Certified Action
of the City of Raleigh Planning Commission

Case File / Name: **SP-86-07 / Alexander Place Retail**

Nature of Case: An 11,570 square foot retail building on a 2.32 acre site zoned Thoroughfare District Conditional Use District with Planned Development District Overlay. The Master Plan governing this tract allows retail in this location but through previous site plans and subdivisions, only 2,500 SF of retail use has been allocated to this particular lot (Lot 3 of S-70-06). The Master Plan requires public review for any increase in retail square footage over 10%. This request equates to a 362% increase in the retail square footage assigned to this particular lot and a 41% increase in the retail square footage assigned to the parent tract in the Master Plan. This lot was created out of a 13.96 acre tract which was allocated a total of 22,000 square foot of retail use within the Master Plan. The land area devoted to retail use is not being increased by this request, just the intensity of the retail use. As this request does not exceed an increase in retail square footage beyond an additional 25,000 square feet, over and above the 22,000 square footage originally allo

SP-86-07 / Alexander Place Retail – Site Plan

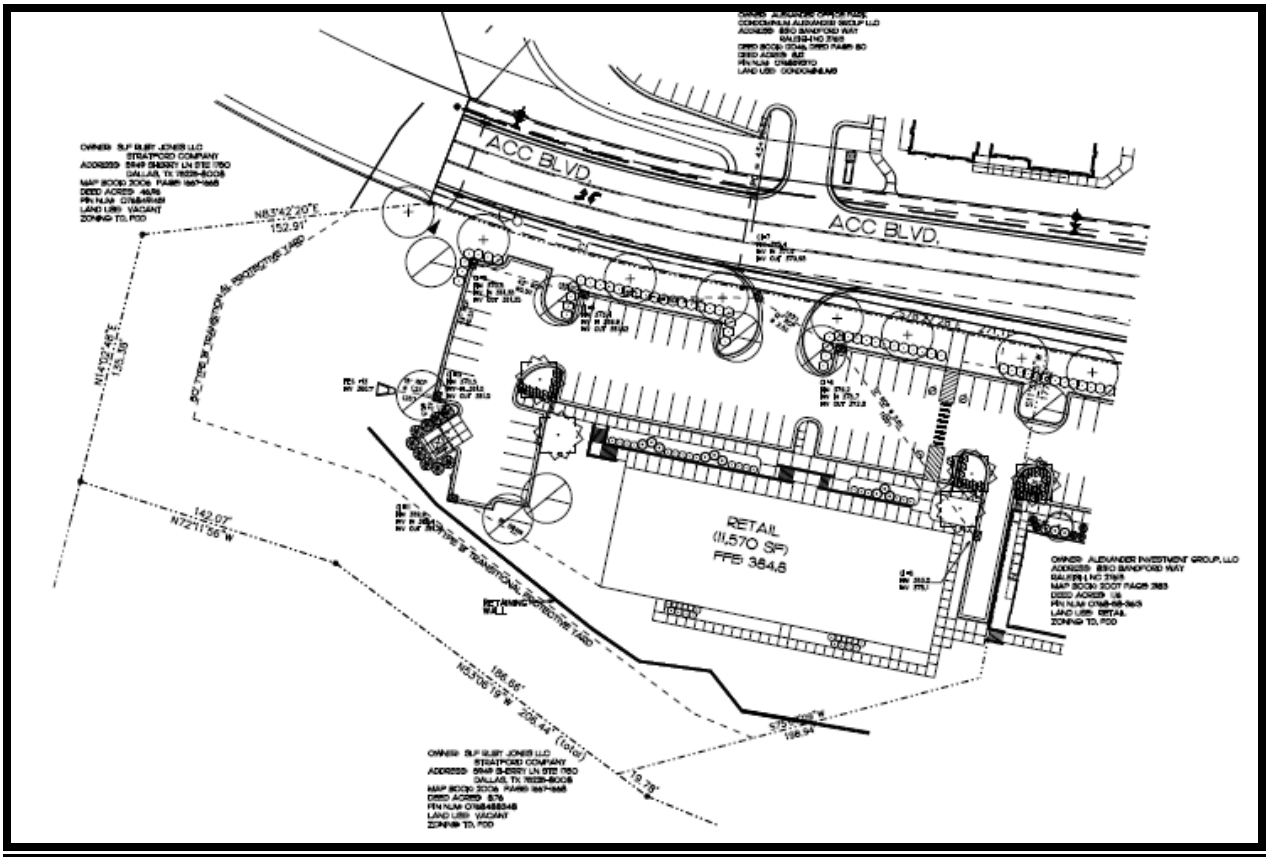
Comment	Response
1. Final building elevations should match the character of and reflect the same degree of detail as the elevation drawing.	Final Elevations will reflect the same detail as that submitted.

2. The retaining wall in front of the building should be of brick, matching the main body of the building.	Retaining wall shall match the brick of the building

3. Explore opportunities for installing lower light poles (≥ 20') to minimize glare.	We will be utilizing Progress Energy site lights to match the same lights used at the Alexander Office Park across ACC Blvd. from the site. The proposed fixtures are cut-off type lights, so glare is substantially minimized through this design. We will coordinate with Progress Energy with regard to using lower poles.

4. Explore opportunities for adding fenestration on the side elevations, complementing that on the front of the building.	The side elevations have fenestrations, as submitted and presented
